EPC STORMWATER REVIEW COMMENTS
IN ORANGE BOXES WITH BLACK TEXT

GRANDWOOD RANCH

ROAD AND STORM PLANS

LOT 22 MAINTENANCE ACCESS ROAD PLAN

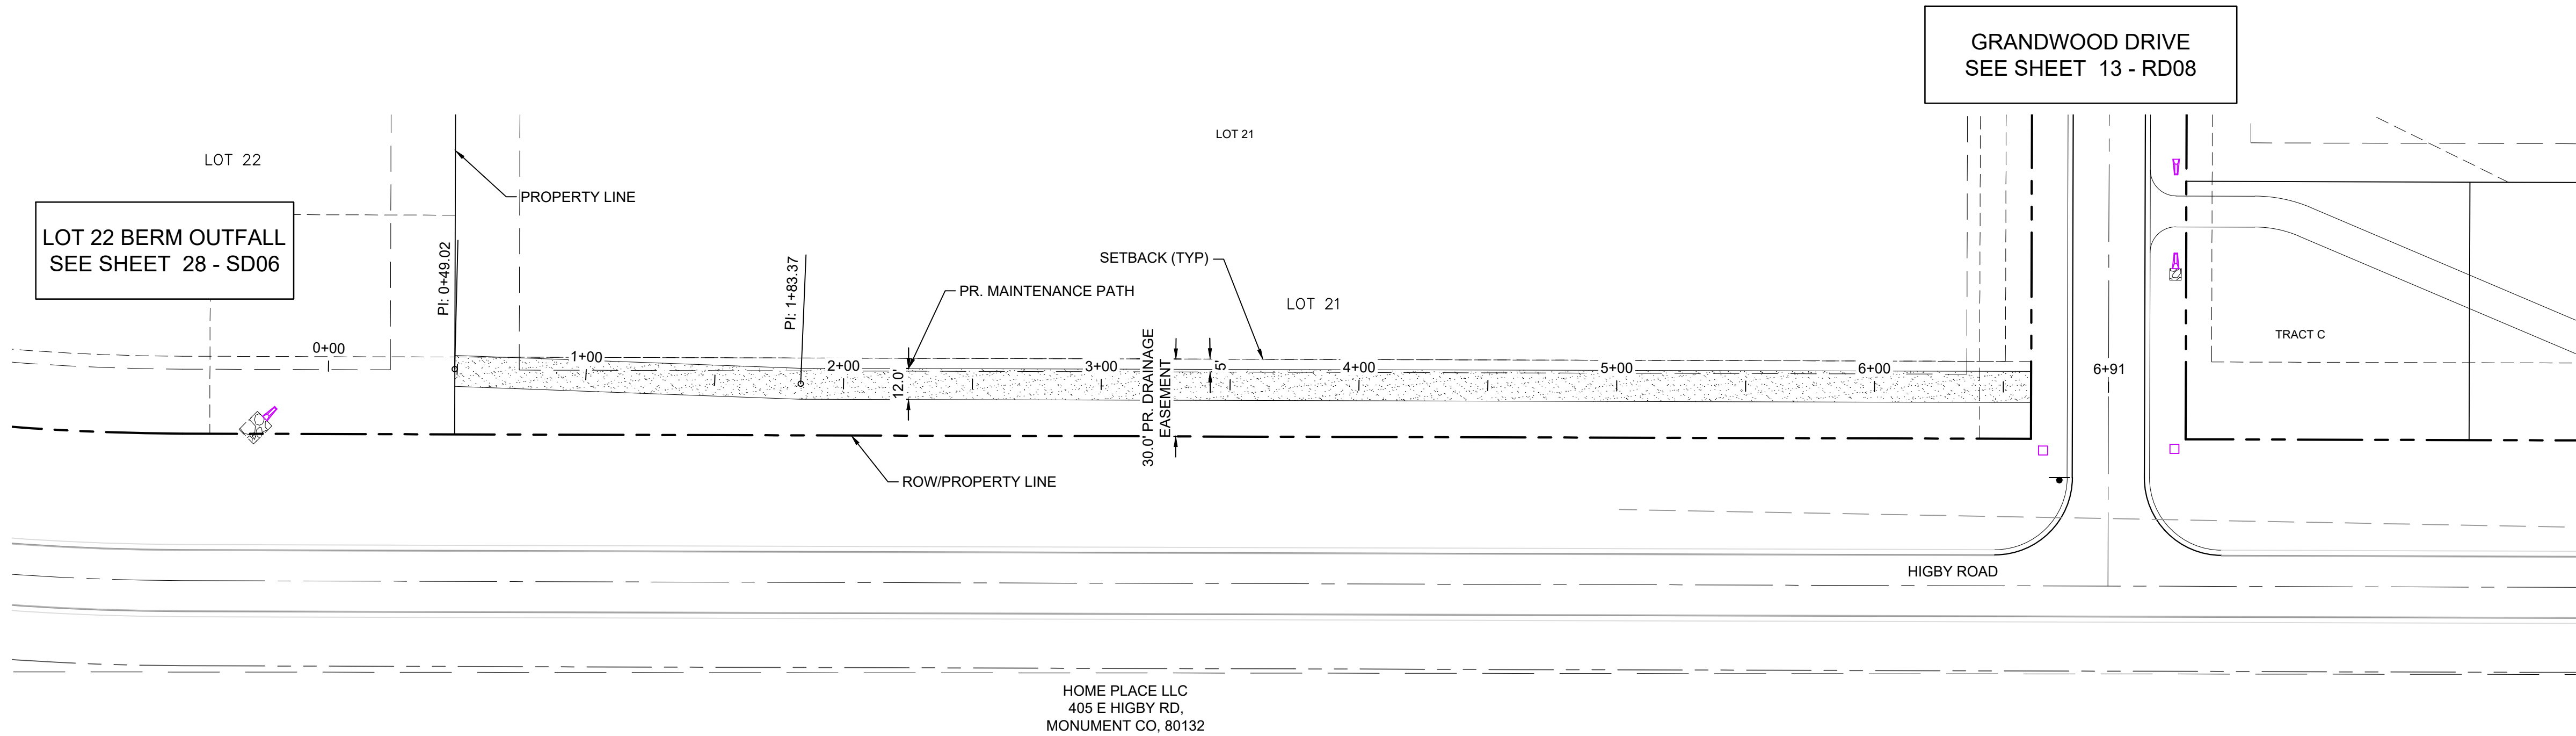
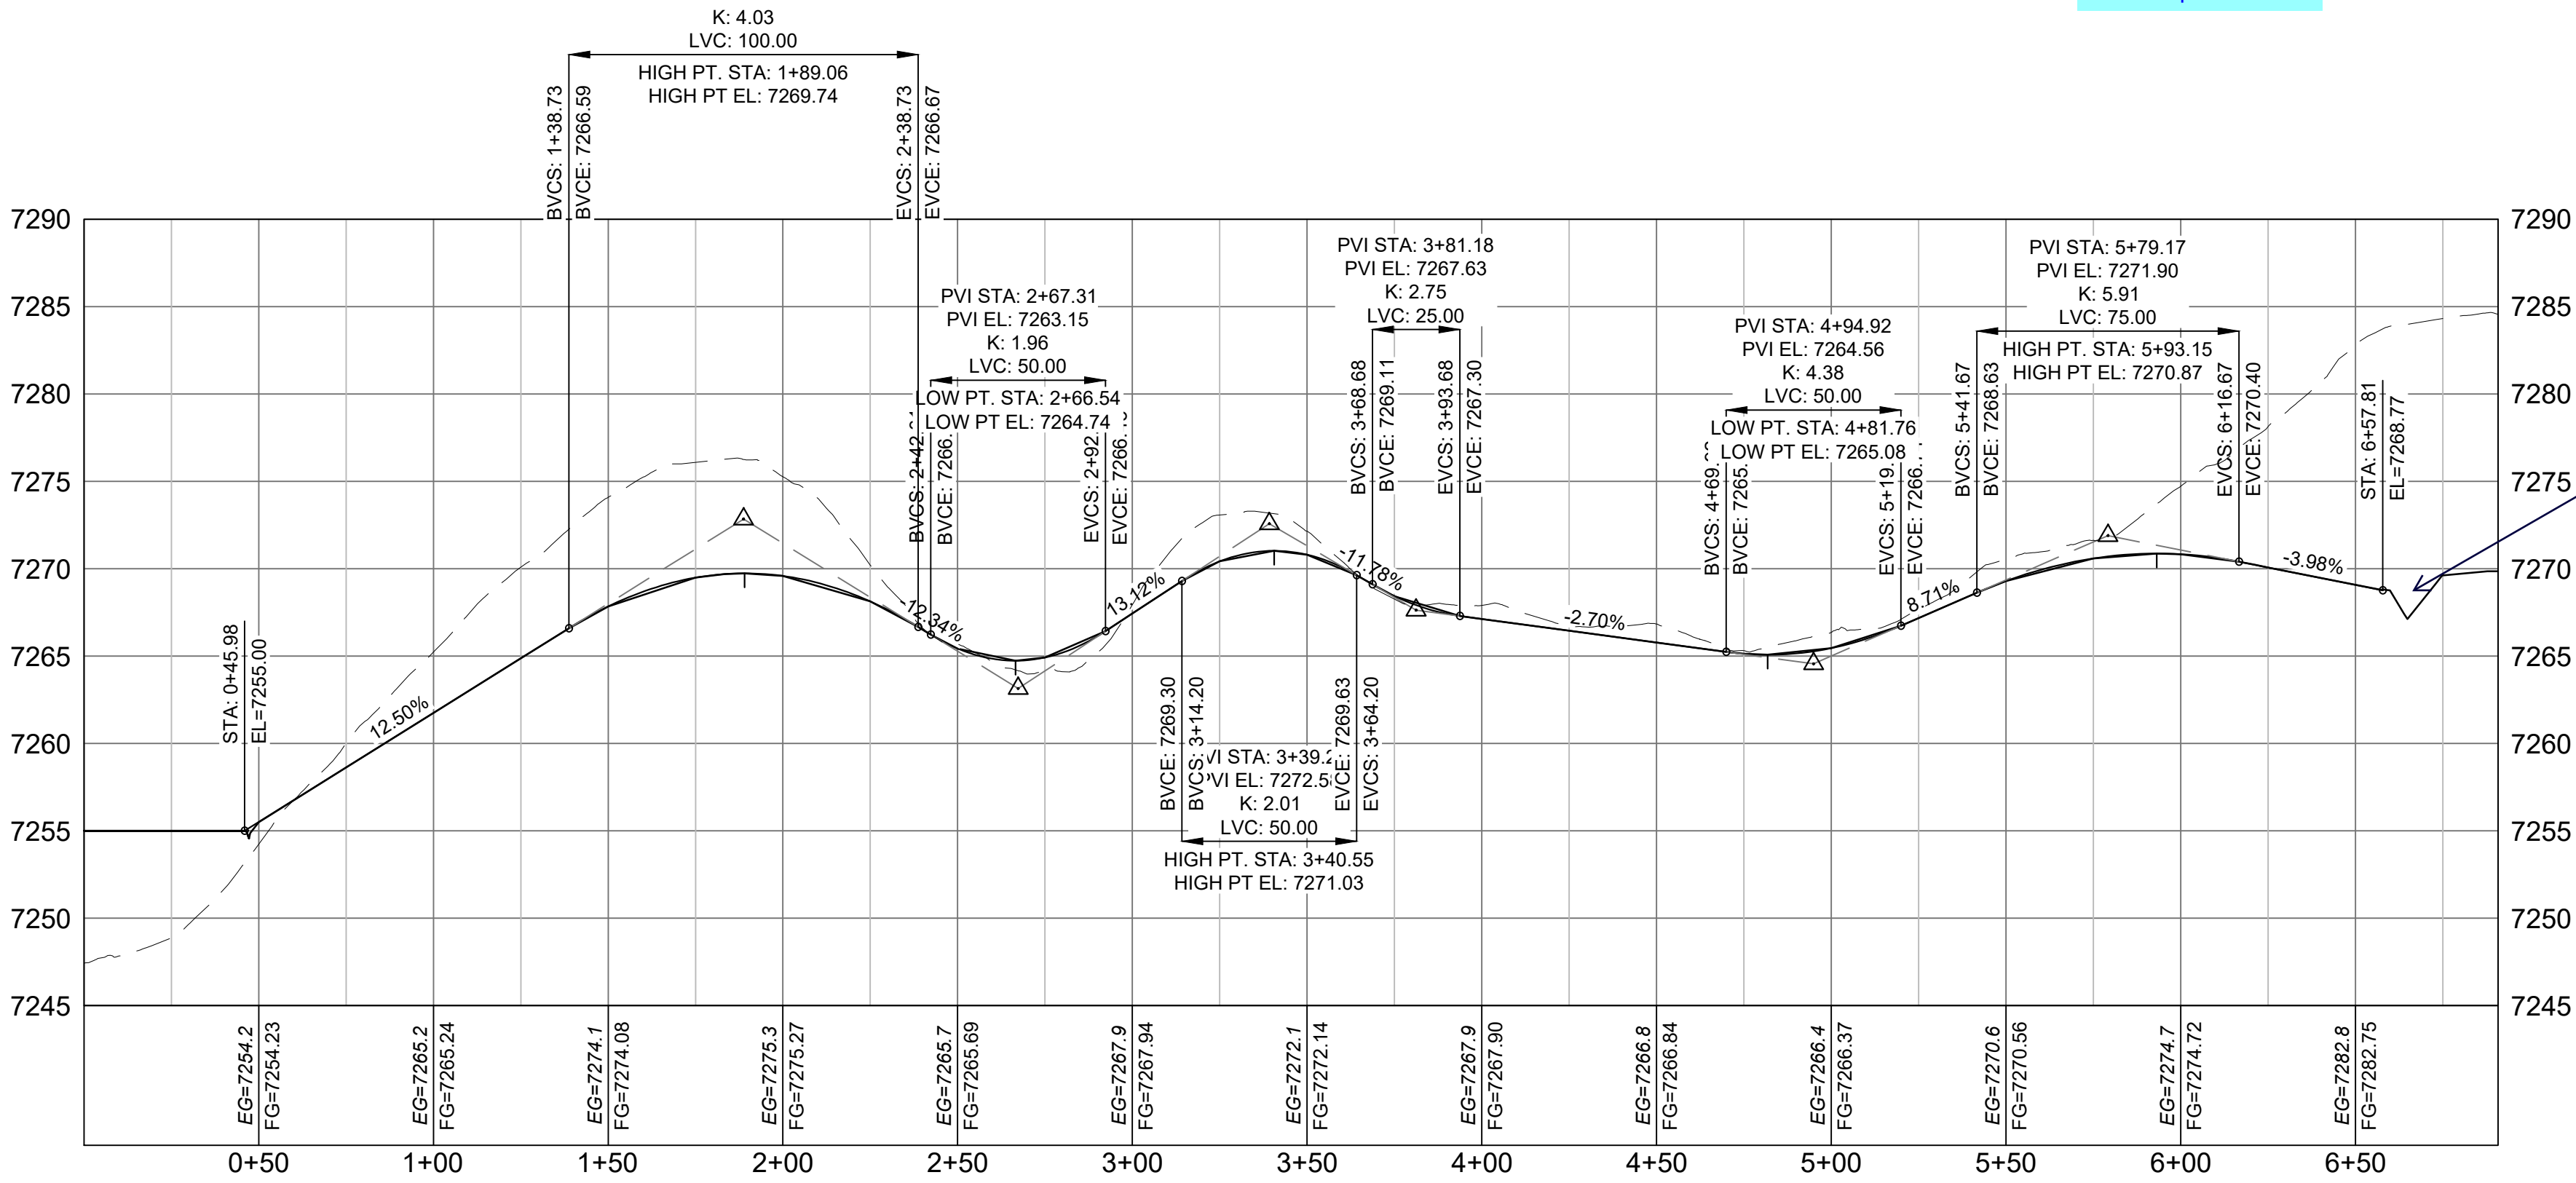
Label as private

appears culvert crossing is required.

The path is located within private lot. Update the plat to add a note if this access is intended to be a shared driveway access with the lot owner or not.

Grading has been revised to allow truck access to the maintenance path. The maintenance path is not intended for shared access. A note has been added to the Plat.

FURROW ROAD STORM PLAN

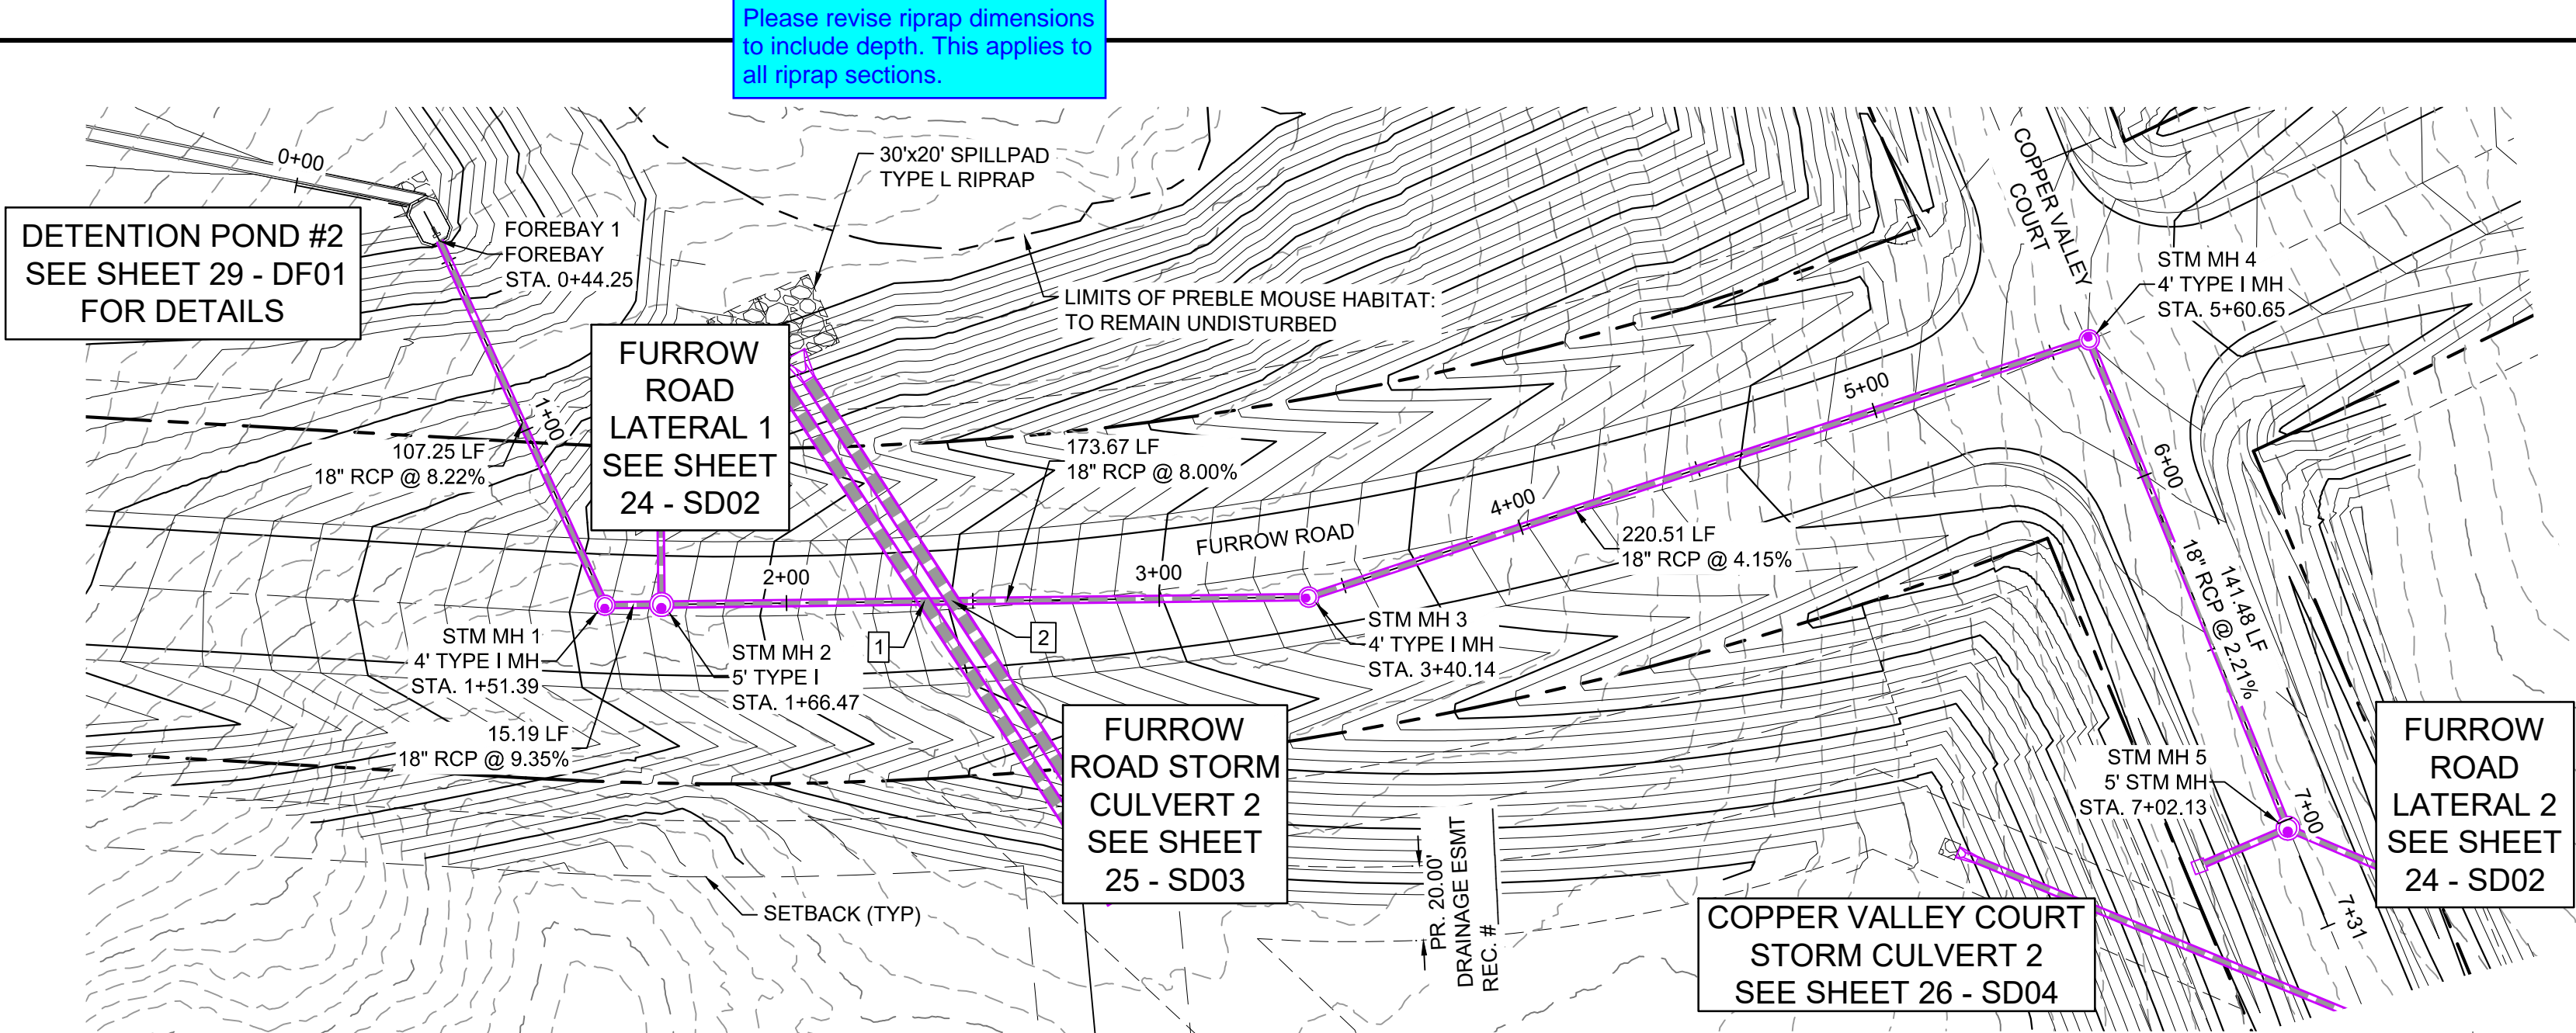
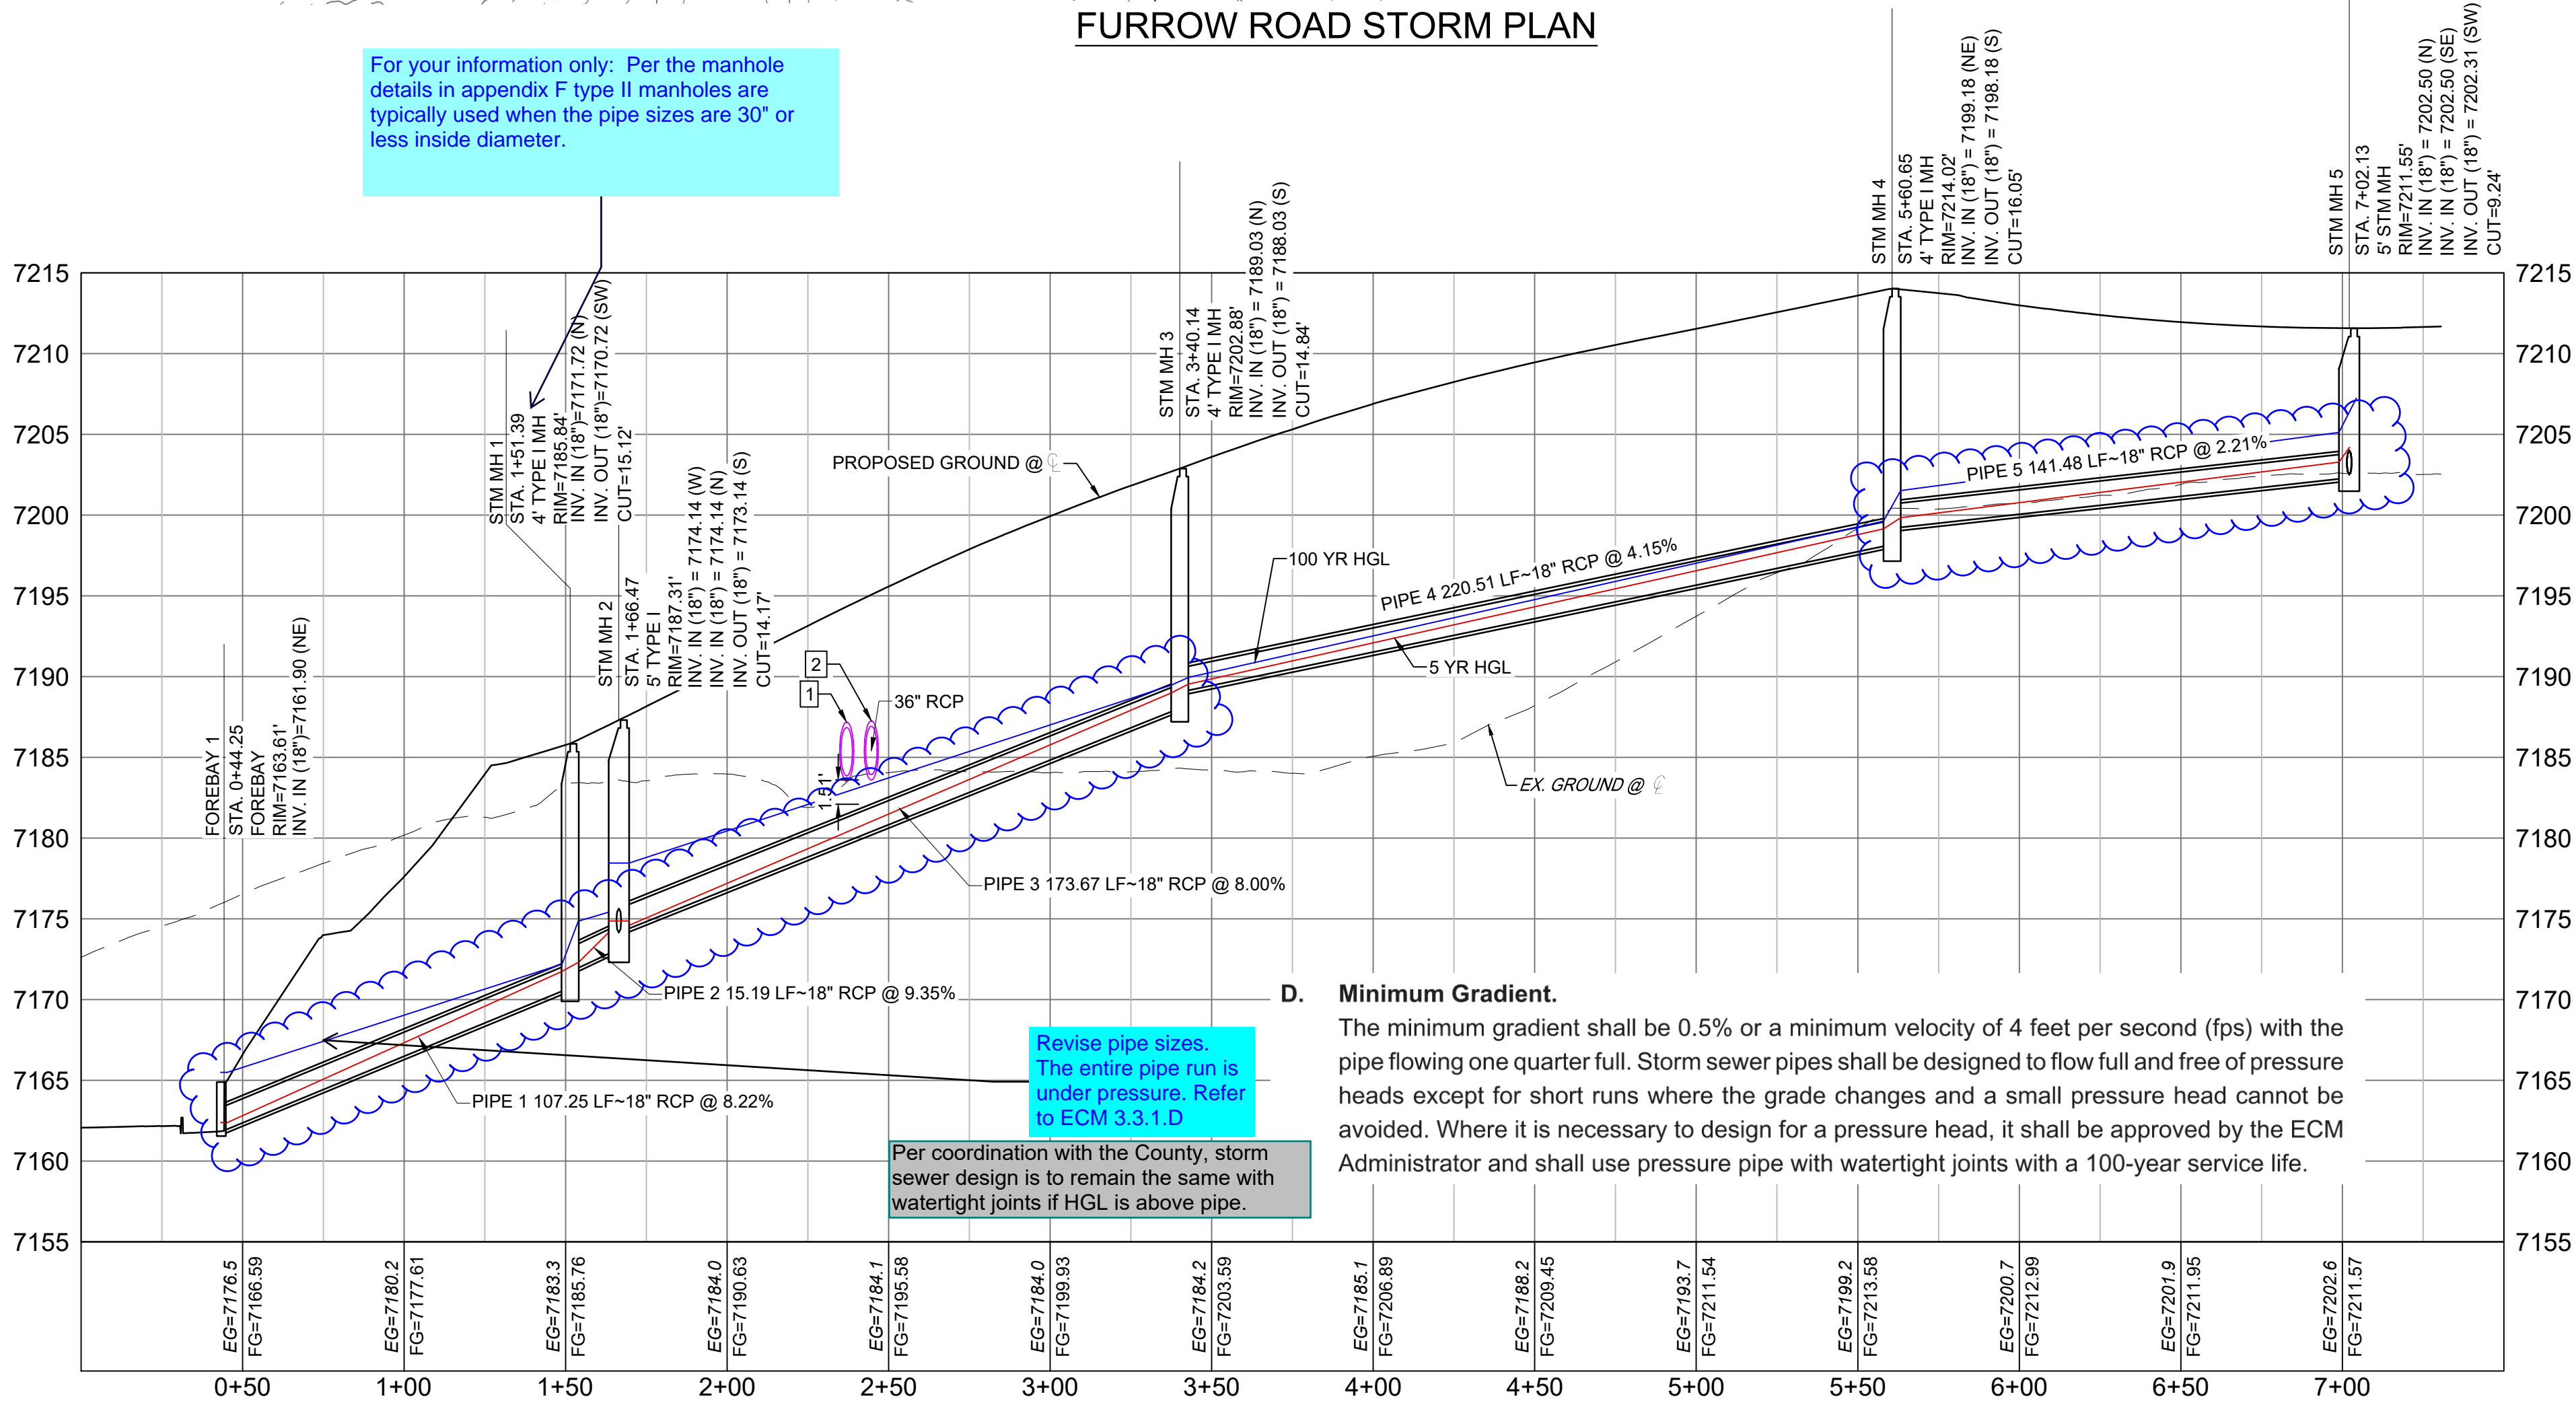
Revise pipe sizes.
The entire pipe run is
under pressure. Refer
to ECM 3.3.1.D

Per coordination with the County, storm
sewer design is to remain the same with
watertight joints if HGL is above pipe.
